Application No. 10/034,686
Amendment Dated May 6, 2004
Reply to Office Action of February 9, 2004
Attorney Docket No.: 38943.1.1.1

REMARKS

Fig. 1

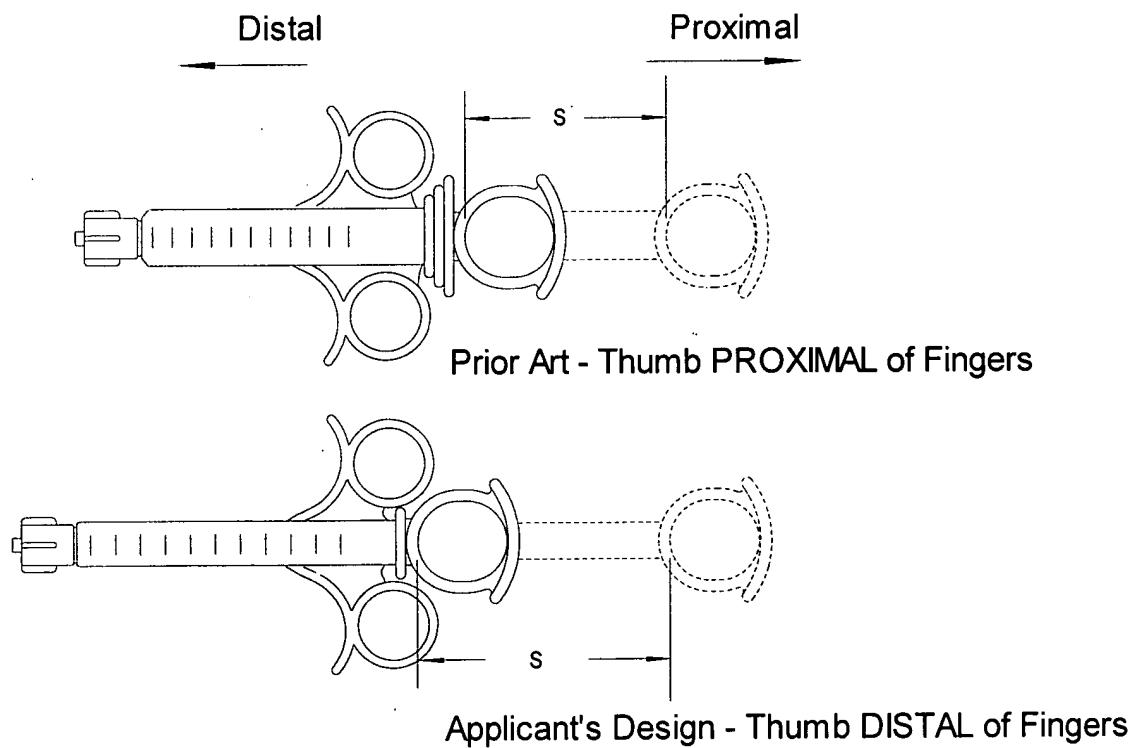
Permission is requested to amend Figure 1 to add the reference character A, together with lead line, as shown in red in the attached Figure 1. The official action noted that the drawing was missing the reference numeral 38, but we find that numeral 38 and appropriate lead line does appear in the drawing of record. For the Examiner's convenience, In the attached copy of drawing Figure 1, the numeral 38 is circled in pencil.
